## **Design Schematics for a Sustainable Parking Lot**

**Building 2-2332, ENRD Classroom,  
Fort Bragg, NC**

## **Final Report**

Figure 22. Scheme C (not to scale) — both aesthetically and technically pleasing, but uses significantly more pavement.

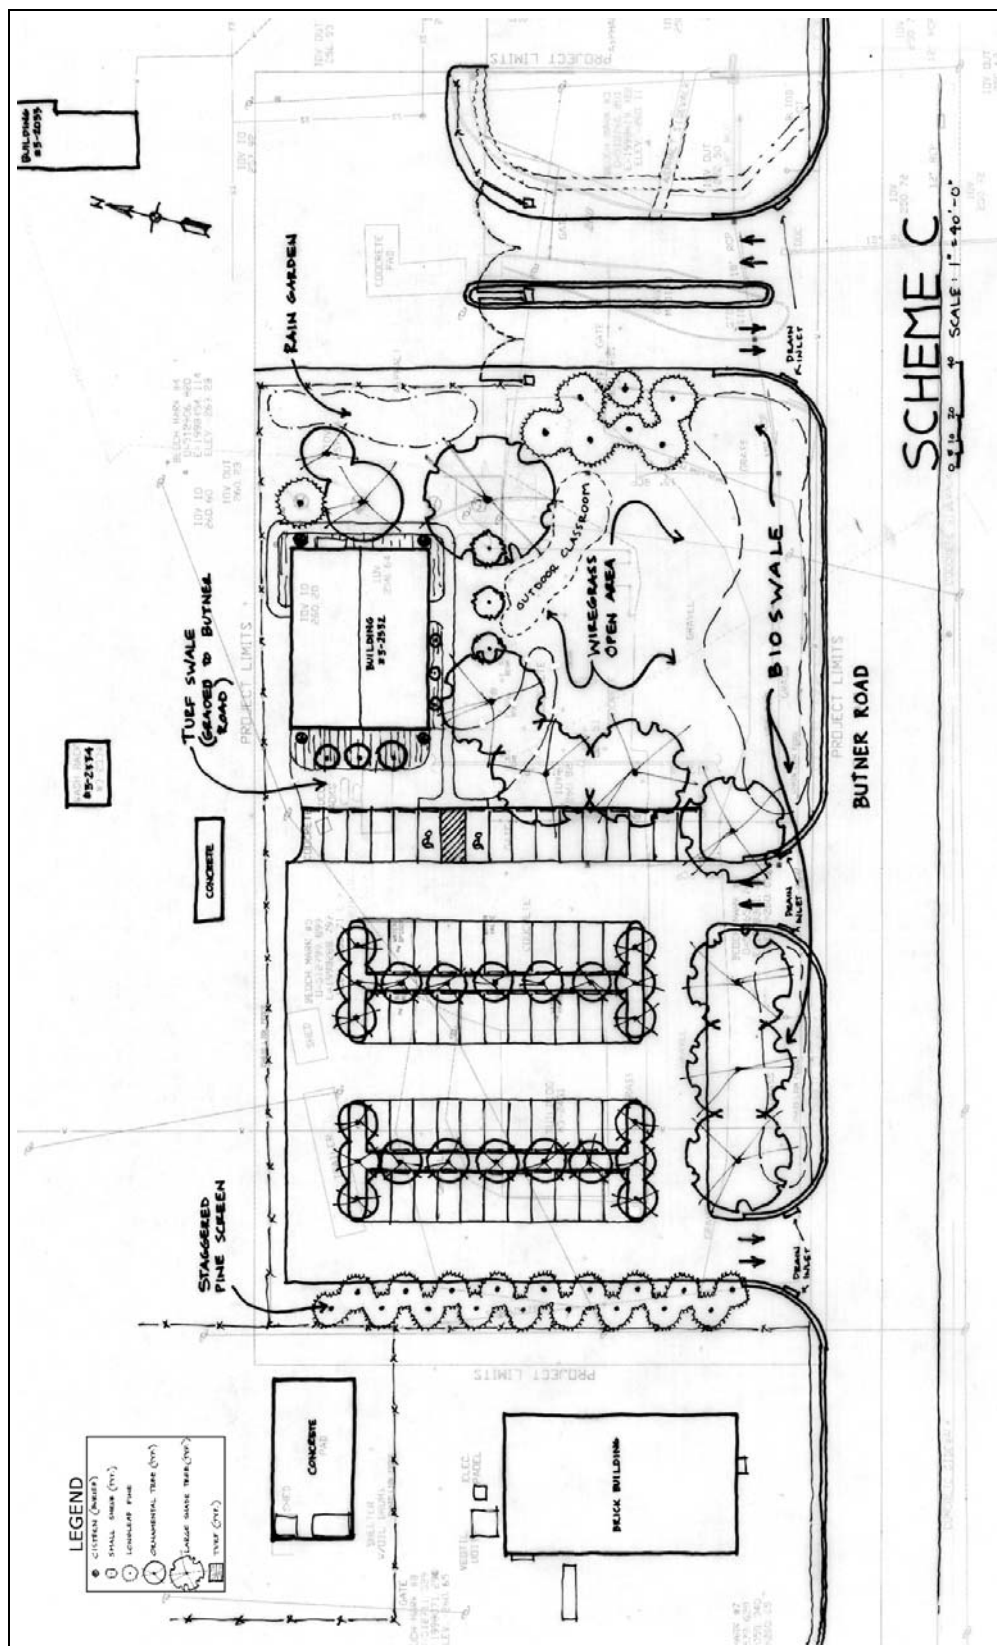
14. Scheme C – need to address pedestrian traffic coming from within the PWBC compound. Add a pervious walkway to the side or front door. Consider adding a sidewalk inside the fence.

Figure 27. Schematic Design "C" with installation comments.

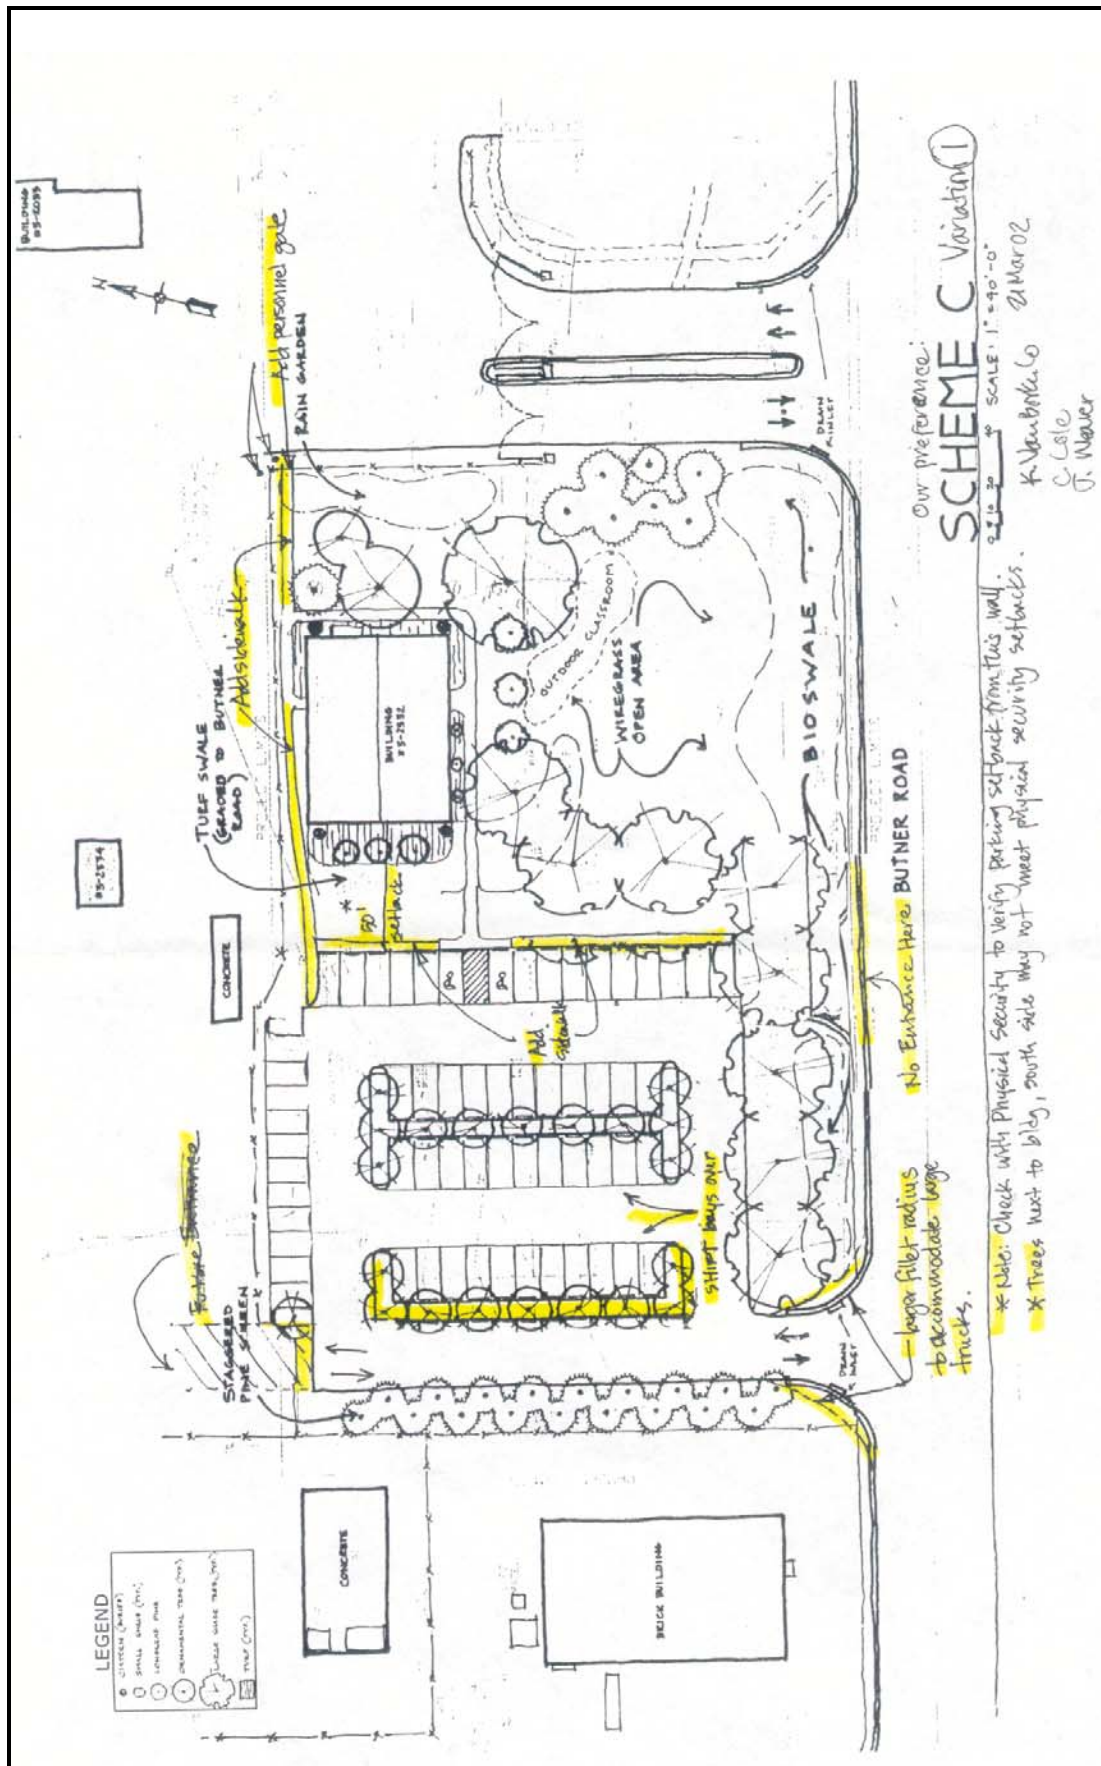
16. Add a bike rack and motorcycle parking.
17. There are drain inlets shown on the driveways. Should be a culvert underneath that has a grate or slit-drain on top to catch any runoff from the parking area. Culvert should dump water into the bioswale or into the underground retention tanks.
